August 14, 2009  
E-28173

Subject: Revision 2 to Transnuclear, Inc. (TN) Application for Amendment 11 to the Standardized NUHOMS® System, Response to Second Request for Additional Information (Docket No. 72-1004; TAC NO. L24080)

References: 1. Letter from B. Jennifer Davis (NRC) to Donis Shaw (TN), "SECOND REQUEST FOR ADDITIONAL INFORMATION FOR REVIEW OF AMENDMENT 11 TO THE STANDARDIZED NUHOMS® SYSTEM (TAC NO. L24080)," March 27, 2009

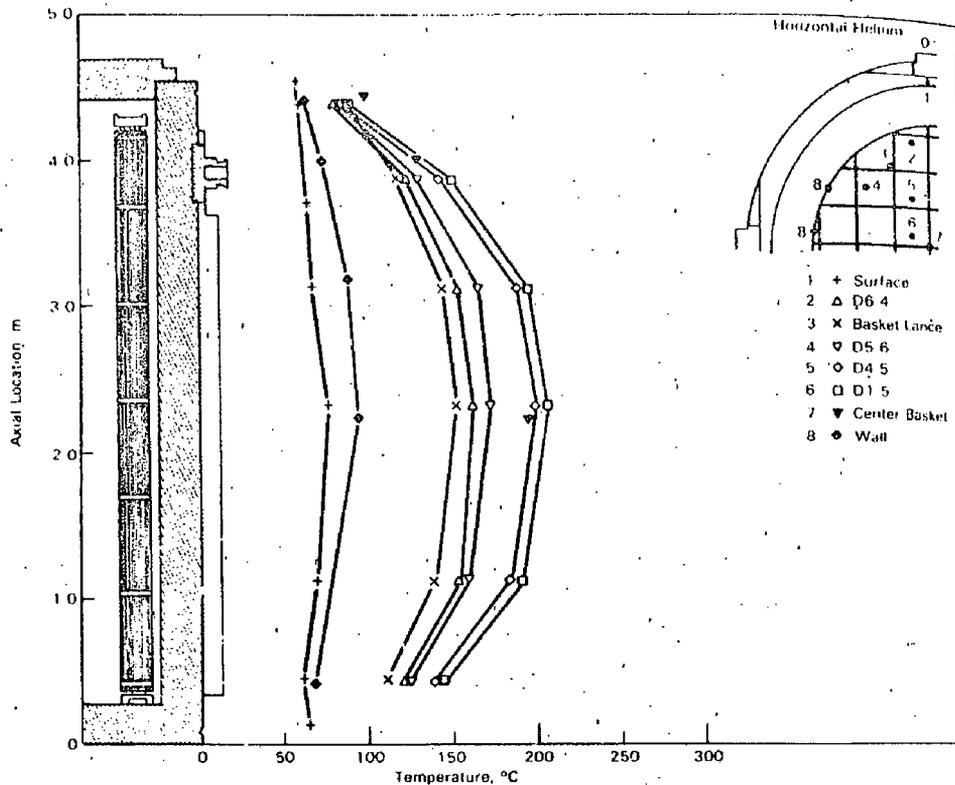
- 3.1 Justify that the assumption of a uniform heat flux at the transfer cask outer shell is a conservative representation of DSC/TC system within the supplemental shielding, and demonstrate that it can produce a conservative estimate of the temperature distribution on the transfer cask outer shell.

In the FLUENT model of the OS197L on the transfer skid enclosed with the supplemental shielding, the assumption of a uniform heat flux at the transfer cask outer shell is a significant simplification in the boundary conditions. It does not account for the variation in heat transfer on the transfer cask shell, due to variation in the surface heat transfer coefficient around the circumference of a horizontal cylinder. It also assumes that the heat flux is uniform along the entire 183.85-inch axial length of the neutron shield, as well as around the circumference of the 40.18-inch diameter neutron shield. (Note that this temperature distribution provides boundary conditions for the next step in the analysis, using a 2D ANSYS model of the OS197L transfer cask.)

***Physical Testing: The use of a uniform decay heat flux is validated by physical test data. For example, Figure 4-14 in the report, "The TN-24P PWR Spent-Fuel Storage Cask: Testing and Analyses," EPRI, EPRI-NP—5128, (PNL-6054), 1987, illustrates the measured temperatures on a horizontal TN-24P cask with a helium backfill. As seen, while the axial variation in the measured fuel cladding temperature clearly shows the effect of the decay heat peaking factor, the axial variation in temperature is largely not present for the temperature distribution at the edge of the basket (i.e., T/C #8) and is barely noticeable for the temperature distribution along the outer edge of the cask body (i.e., T/C #1). These results clearly demonstrate that the use of a uniform decay heat flux along the outer wall of the cask, especially if combined with end effects, would yield the same nearly uniform cask surface temperatures with a slight fall off at the ends as seen in the actual testing. Thus, the validity of using a uniform heat flux to support the calculation of the temperature distribution on the cask is supported by test data.***

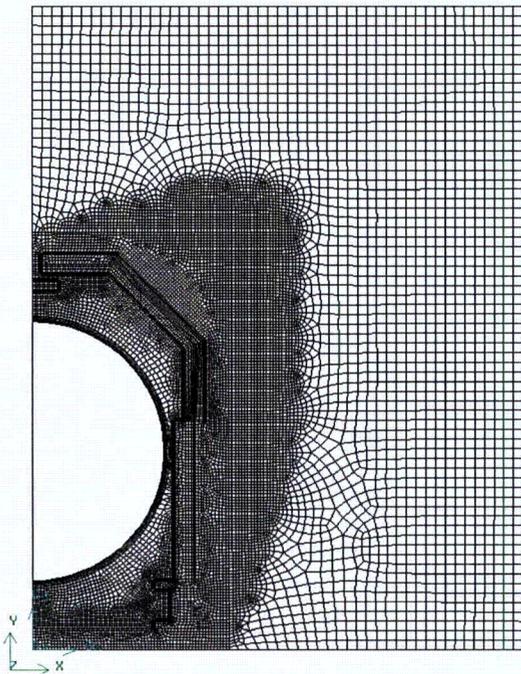
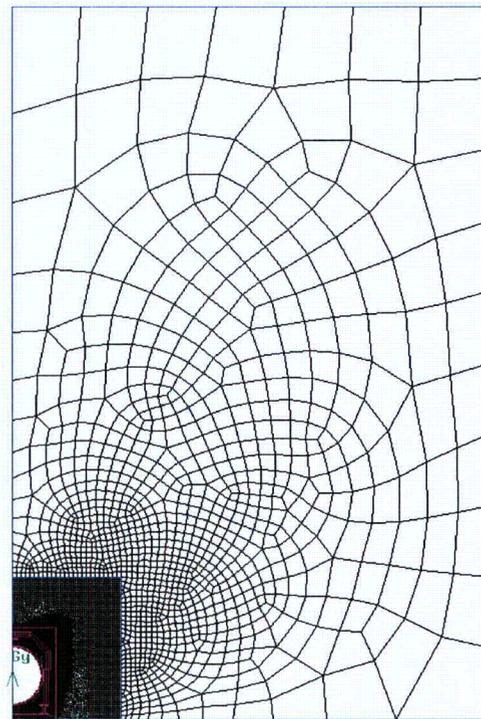
The size of the exterior fluid mesh in the FLUENT model of the OS197L transfer cask within the supplemental shielding may not be sufficient to extend to true ambient temperature. The mesh extends only about 1.5 to 2 IJD beyond the outer surface of the supplemental shielding into the surrounding air. Typically, the transition length is on the order of 5 to 10 L/D for thermal and velocity gradients in an infinite medium. The effect of truncating the distance to ambient would be non-conservative; it would overstate the steepness of the temperature gradient to ambient, resulting in a higher heat transfer rate than can actually be obtained.

*By definition, the thickness of a thermal boundary layer is measured by the distance from the surface to the point at which the flow temperature is within 99% of the free stream temperature. Since the boundary layer thickness on the auxiliary shielding will not be more than a few inches thick at most (based on logic, hand calcs, etc), the 'steepness' of the temperature gradient is not over stated by the positioning of the ambient boundaries 75 to 100 inches away, as used in the CFD modeling. What can be affected by the proximity of the ambient boundary are the velocity and pressure profiles, which in turn have an impact on the boundary layer calculation. However, given the relatively low flow velocities and delta pressures associated with this case, the effect on the computed surface temperature was expected to be only minor and it was expected that these effects would diminish in proportion to the separation distance between the ambient boundary and the auxiliary shield wall. As such, no significant impact was expected by the selection of the ambient boundary positioning used in the modeling. To verify this conclusion, a sensitivity analysis was conducted using an extended computational mesh which extends the ambient boundaries from 150 to 660 inches in the x-direction and from 200 to 1,000 inches in the y-direction (see figures below). This increase in dimensions provides a transition length of 5 to 10*

*It was noted that the extended mesh setup has more difficulty in achieving a steady-state solution at the top of the cask shell in terms of a symmetric temperature distribution pattern along the z-axis. After numerous runs with variations in the under relaxation factors, pressure-velocity coupling method, and extended consultation with FLUENT technical support, it was concluded that the turbulent nature of the heat transfer at this portion of the cask shell was the root cause of the non-symmetry. This conclusion is supported by the fact that extending the number of iterations yielded a cyclic repetition in the temperature distribution pattern, but with little change in the resultant peak, minimum, and average cask shell temperature between iterations. While exercising the model in a transient mode and averaging the temperature results could be used to yield a time-averaged solution, the added effort was deemed not necessary for the purpose of addressing the sensitivity of the solution to the placement of the ambient boundary condition.*

Original Computational Mesh

Extended Computational Mesh

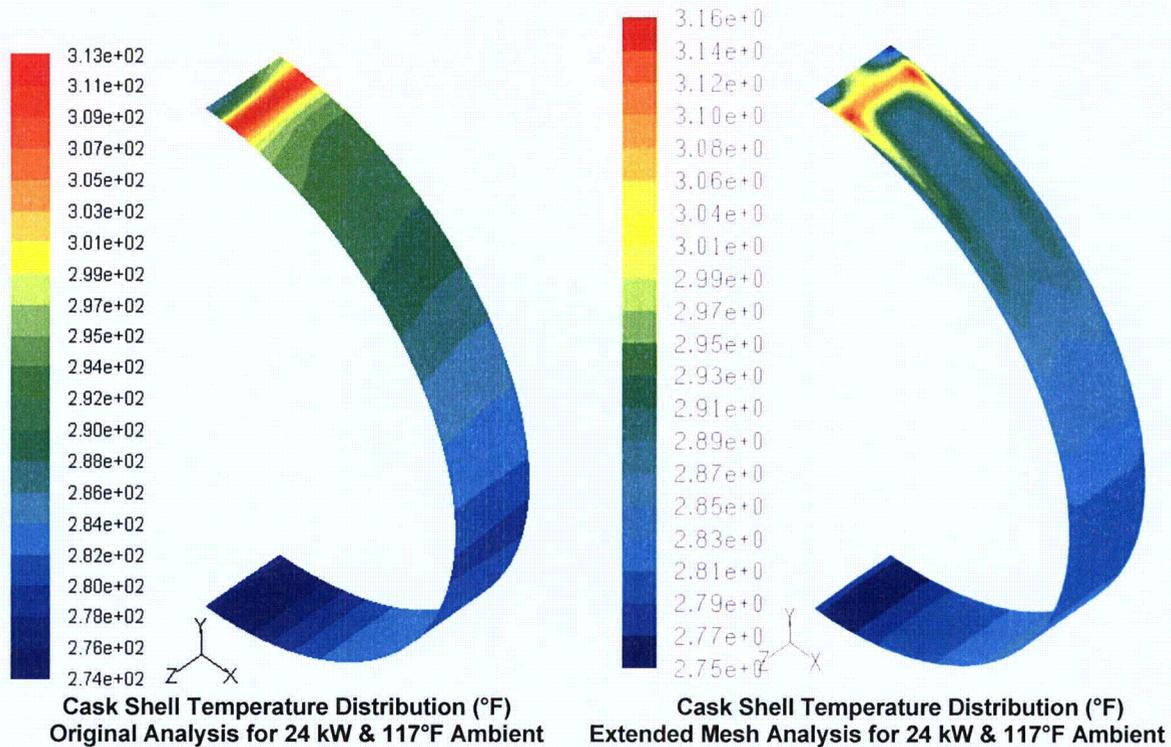
- 3.4 Justify that the analysis results presented in Figures W.4-5 and W.4-9 result from a conservative representation of DSC/TC system within the supplemental shielding, and demonstrate that this is a conservative estimate of the temperature distribution on the transfer cask outer shell.

The temperature graphics in Figures W.4-5 and W.4-9 show an off-set peak temperature location on the TC outer shell that does not appear to be consistent with natural convective heat transfer or with the flow field velocity vectors shown in Figures W.4-7 and W.4-8. (Note that this temperature distribution provides boundary conditions for the next step in the analysis, using a 2D ANSYS model of the OS197L transfer cask.)

*The temperature graphics in UFSAR Figures W.4-5 and W.4-9 are consistent with the flow field velocity vectors depicted in Figures W.4-7 and W.4-8. The temperature graphics are not consistent with the natural convective heat transfer profile expected for an isolated cylinder because the transfer cask is not situated in an isolated environment, but is housed within the auxiliary shielding. As described on page W.4-6, the peak temperature on the cask shell is predicted to occur back from the centerline of the cask at the point where the flow separates from the cask and heads towards the exit. The fact that the cask shell temperature reaches a peak and then decreases slightly at the very top of the cask is attributed to the presence of a flow recirculation in this region caused by the presence of the steel plate positioned above the cask shell and below the vent slot in the trailer shielding. The plate's positioning is set to prevent direct line-of-sight between the cask and the ambient while allowing the ventilation air to exit the trailer shielding. However, the plate's positioning also alters the pressure field near the top of the transfer cask from that which would occur for an isolated cylinder and this altered pressure field causes the boundary layer flow around the transfer cask to stagnate and separate earlier than it would for an isolated cylinder. Because of this, a recirculation zone is created between this offset*

*point of flow stagnation and the centerline of the cask. A close examination of Figure W.4-8 will show the presence of this recirculation zone, although the scale of the figure makes it difficult. An enlarged view of the velocity field in this region of the model presented below clearly demonstrates the presence of the recirculation flow at the top of the cask. Since it is the stagnation zone that experiences the highest surface temperature, the temperature distribution illustrated in Figures W.4-5 and W.4-9 correctly depicts the location of elevated shell temperature at the region of the cask shell where the circumferential flow stagnates and detaches.*

*Although the figure above is for OS197L with a 24 kW heat load, a similar flow re-circulation zone exists for the OS197L transfer cask with a heat load of 13 kW and the justification provided in this response applies for the 13 kW heat load as well. See the revised text and the figure added in Chapter W.4 of updated SAR to address this RAI.*
